# Memorandum

To: Maureen Bilawchuk (ENV) Ref. No.: 11149336

**Subject: Supplementary Review of Monitoring well MW-6  
Cobble Hill Landfill  
460 Stebbings Road, South Shawnigan Lake Area, BC**

FIGURE 1

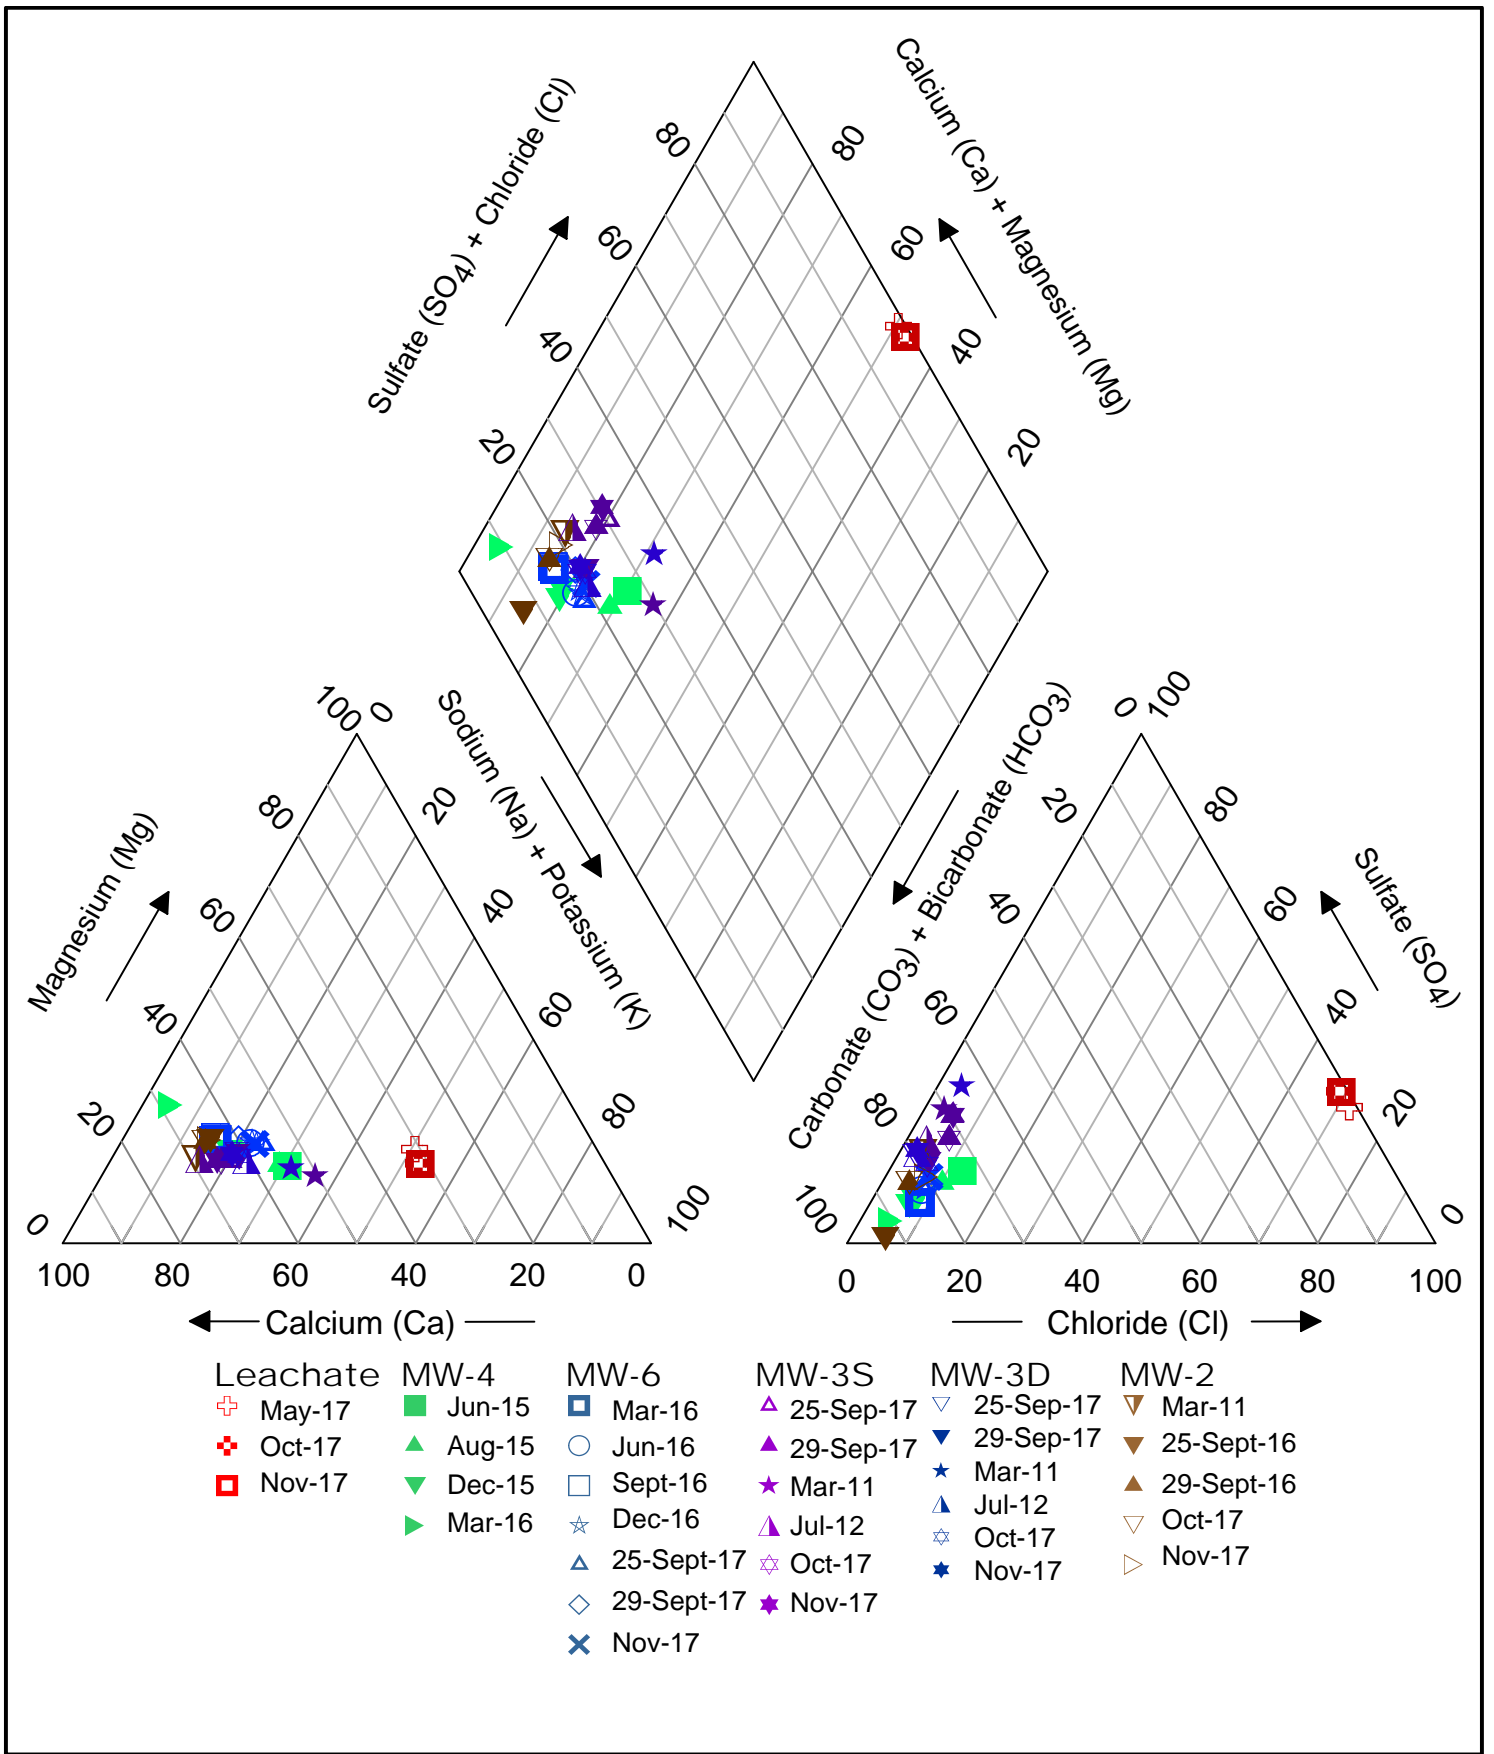
Figure 1 provides the piper plot generated using water quality samples from on-Site monitoring wells MW-2, MW-3S, MW-3D, MW-4 and MW-6. In addition, leachate samples collected during the 2017 monitoring period have been plotted for comparison purposes. There are three important observations made from the piper plot:

- The geochemical characteristics of water quality from all on-Site monitoring wells are very similar, as they plot in the same portion of the diamond.
- The geochemical characteristics of water quality from water samples collected before landfilling are essentially the same as those collected after landfilling.
- The geochemical characteristics of leachate are very different than those of the groundwater quality samples.

The pattern of water quality distribution on this plot supports the interpretation that water quality samples from the on-Site monitoring well network are not affected by leachate. If the water quality at a monitoring well was affected by leachate, the geochemical characteristics would bear a closer resemblance to leachate and the sample would plot closer to the leachate samples on the diamond. In typical circumstances where samples from a variety of monitoring wells are variably affected by a single contaminant source, the wells that are more affected by the contaminant source plot closer to the contaminant source samples on the diamond. As the water quality samples from all monitoring well sources over time plot far from the leachate

source samples, and close to each other, the piper plot suggests that none of the monitoring well water quality samples have been affected by leachate.

figure 2  
 Concentration versus Time  
 MW-6  
 Cobble Hill Landfill  
 Cobble Hill Holdings Ltd.

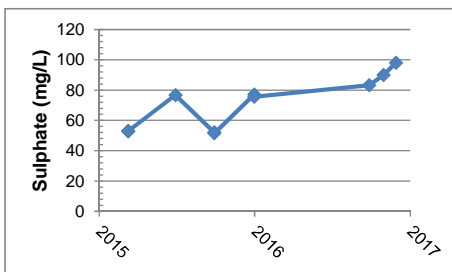
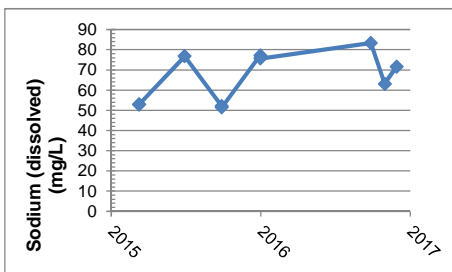
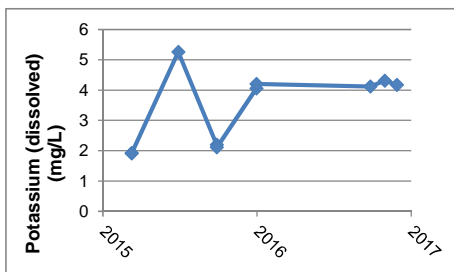
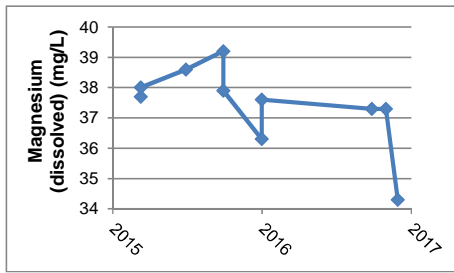
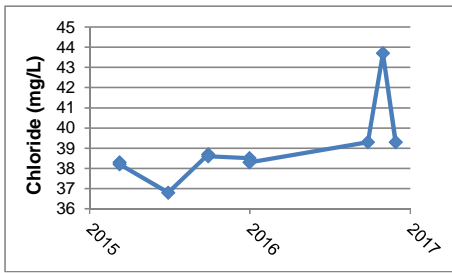
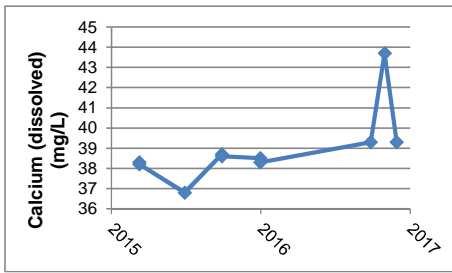
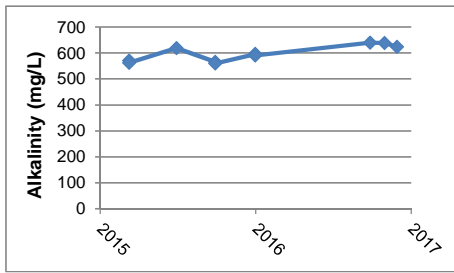
Figures 2 and 3 illustrate the concentrations of alkalinity, calcium, chloride, magnesium, potassium, sodium and sulphate over time at MW-6, MW-2 and MW3S/D. The concentration vs time plots illustrate that, although there is some minor variability in water quality, the concentrations of these indicator parameters are largely stable over time. If there were impacts from landfilling activities migrating vertically through the subsurface and affecting groundwater quality at these monitoring points, clear trends of increasing indicator parameter concentrations would be apparent.

The patterns of concentration vs time illustrated on Figures 2 and 3 support the interpretation that groundwater quality in the on-Site monitoring well network has not been affected by landfilling activities.
